Project No. 0771-356-11-41
June 5, 2023

Re: Response to 1st Technical Notice of Deficiency Letter – Major Permit Amendment Application
Fort Worth C&D Landfill
Fort Worth, Tarrant County, Texas
MSW Permit No. 1983E
Tracking No. 28325020

NOD1 Table - Permit Type IV (Permit 1983E)

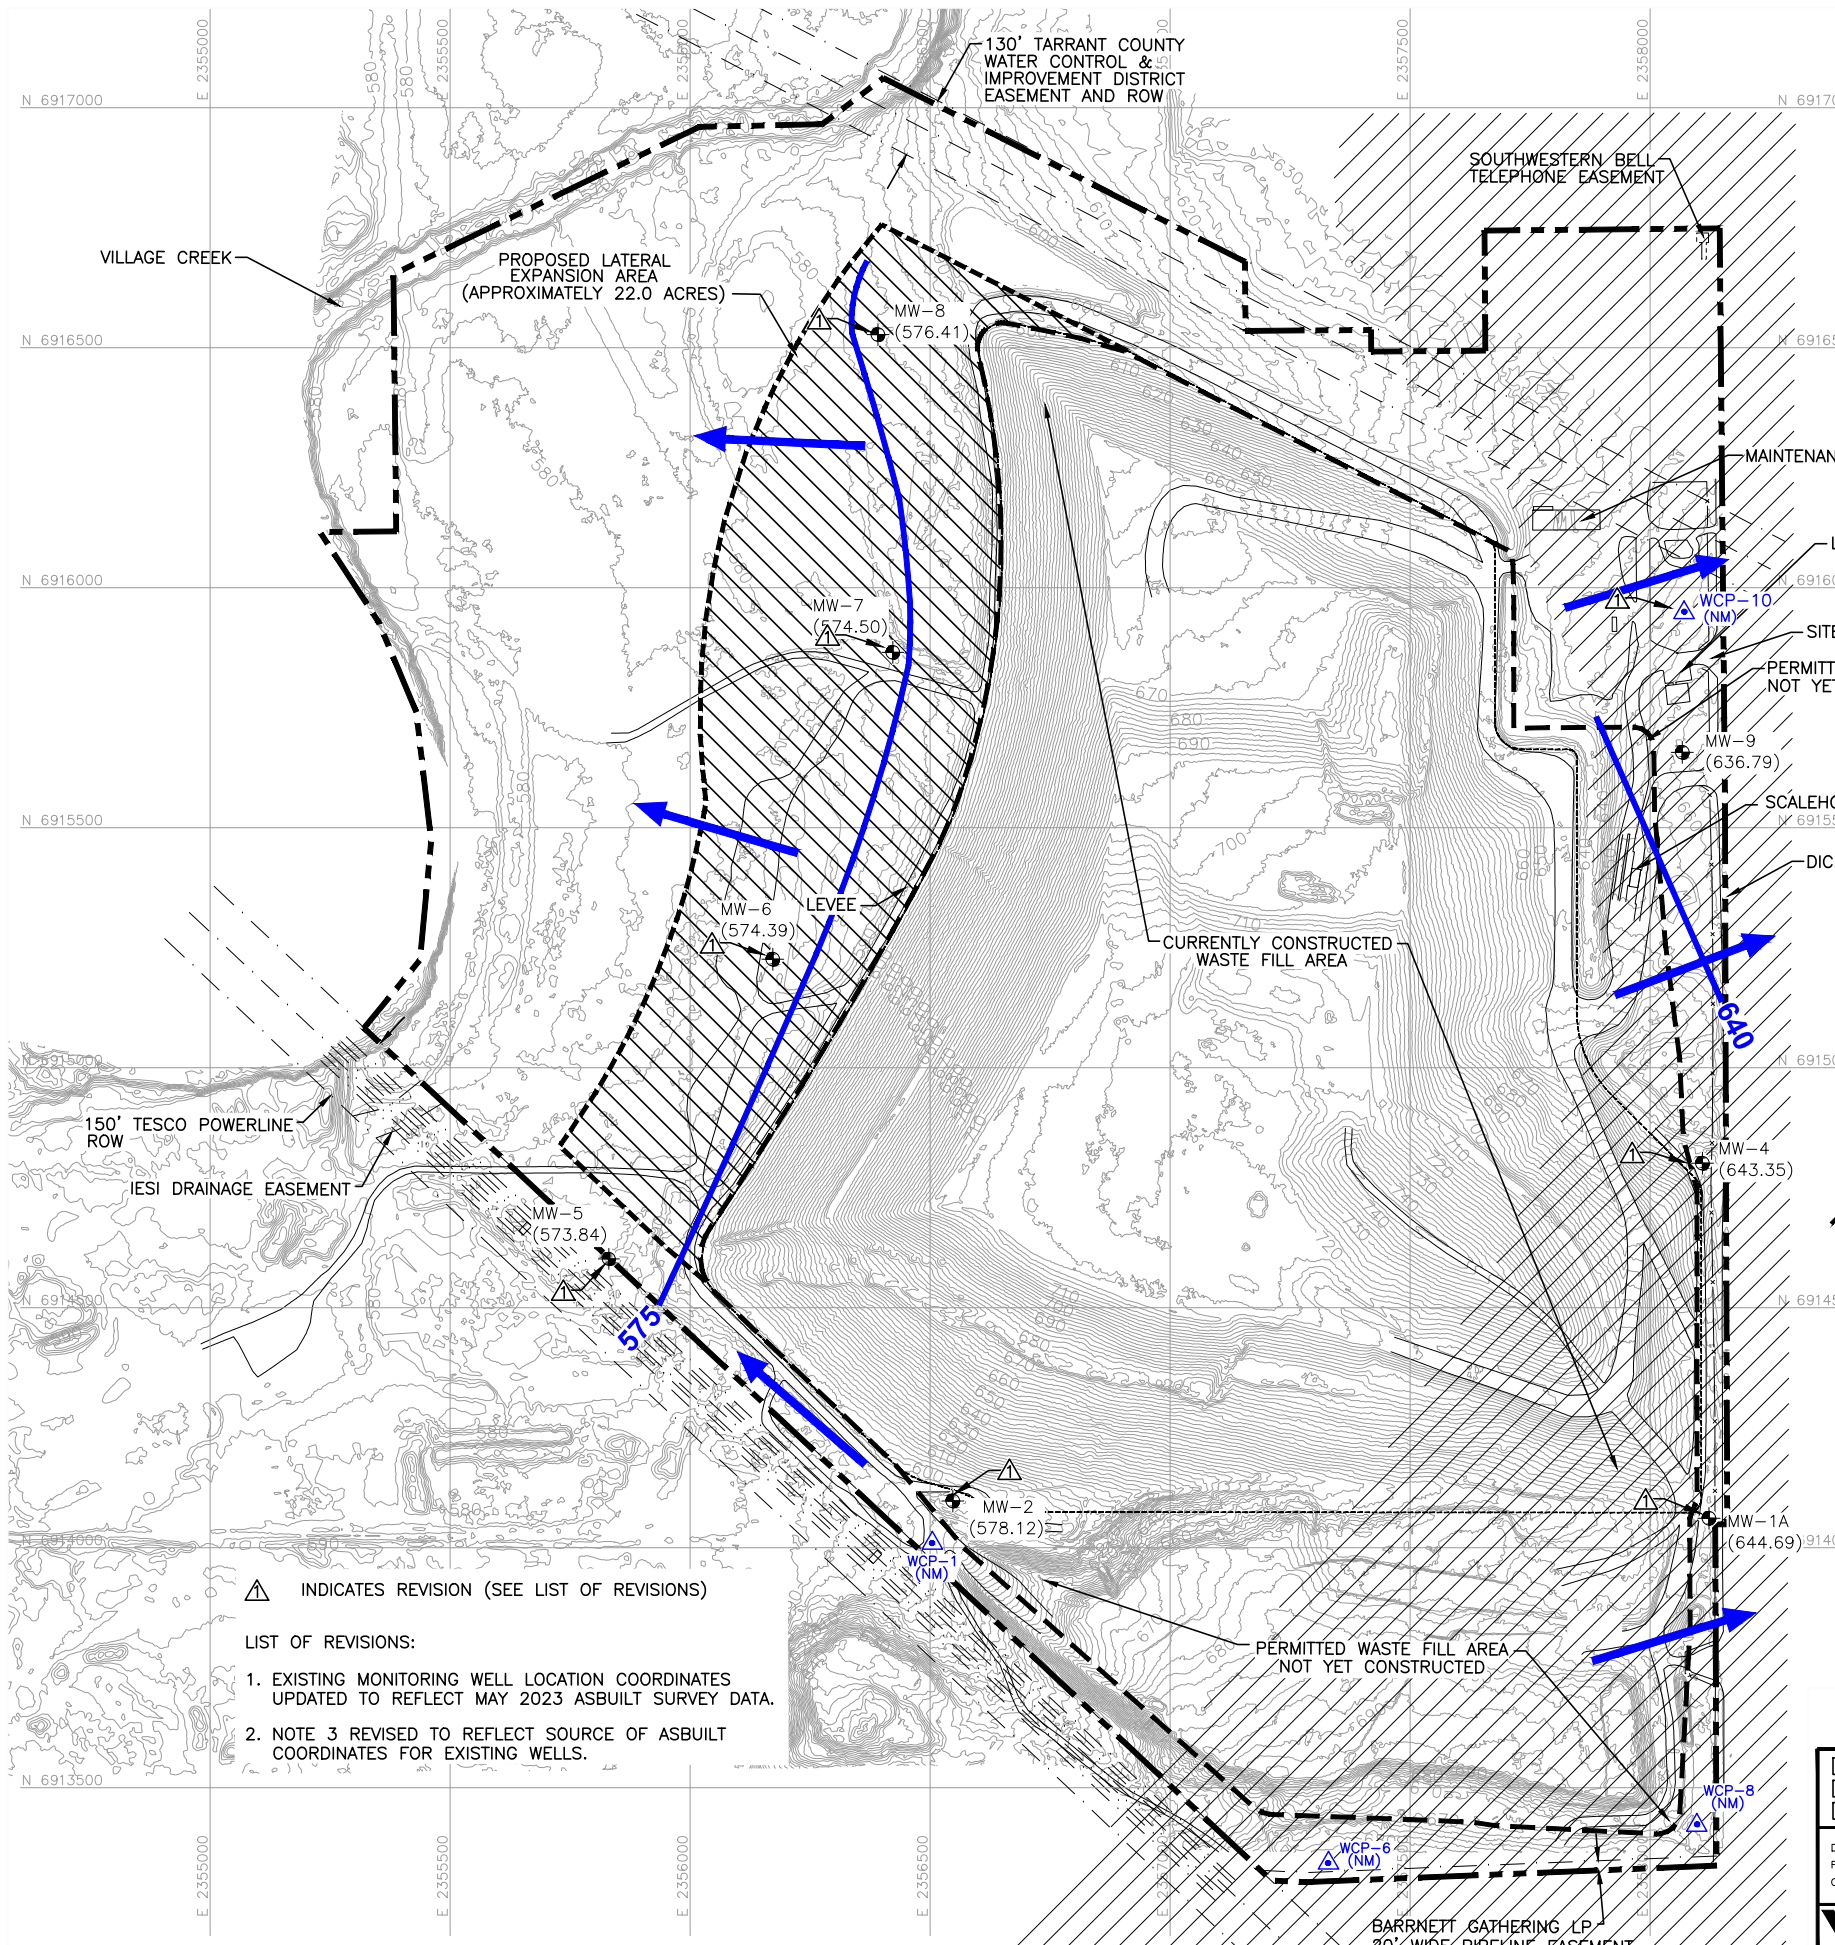
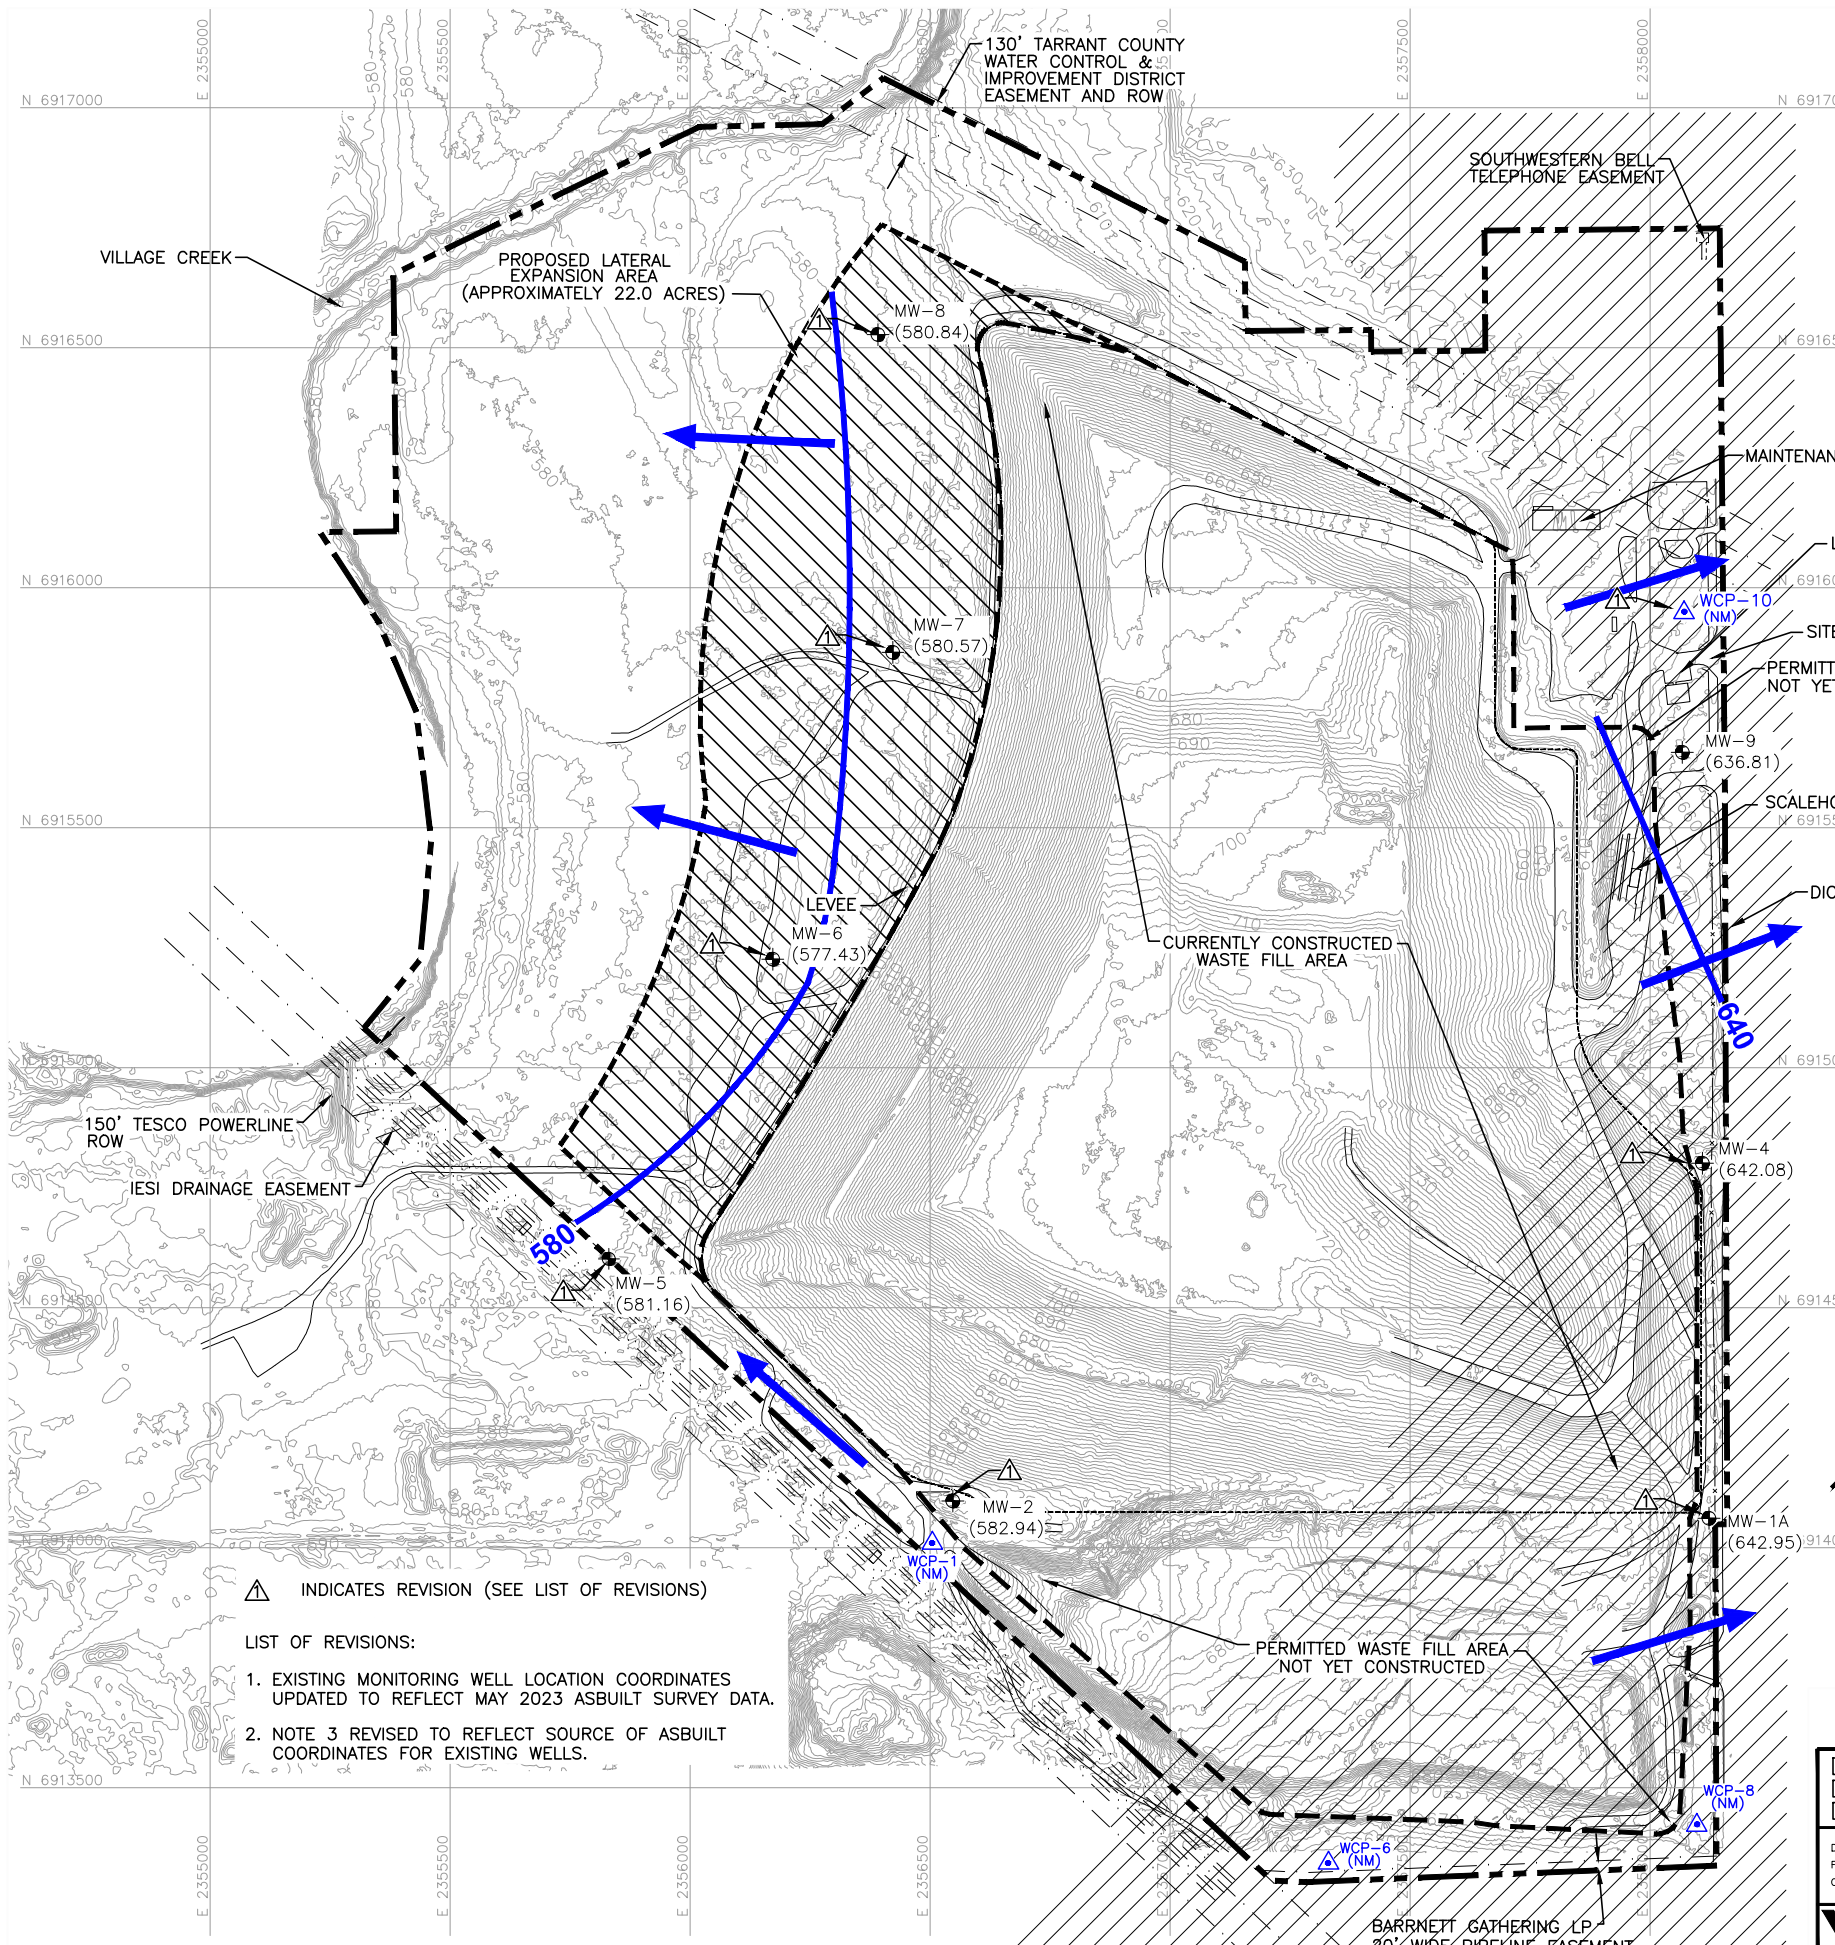
T28	507	Part III	330.63(e)(5)(F)	Ambiguous	<p>Explain the meaning/significance of the Woodbine groundwater contour maps shown on pages IIIG-D-36 through D-38: compare with the cross-sections in Figures IIIG-C-2 through C-9 where the Woodbine formation is missing.</p> <p>Response: The groundwater contour maps on pages IIIG-D-36 through IIIG-D-38 were obtained from the facility's Annual Groundwater Monitoring Reports by The Carel Corporation from the facility's June 2020, 2021, and 2022 monitoring events. Inquiry into these maps indicate that the Woodbine Formation was omitted from consideration in the development of the contours depicted on these maps. However, the groundwater elevation data are accurate and consistent with historical groundwater elevations and were contoured by WCG, consistent with the facility's permitted hydrogeological characterization, as depicted on existing Figures IIIG-D-1 through IIIG-D-3 in Appendix IIIG.</p>
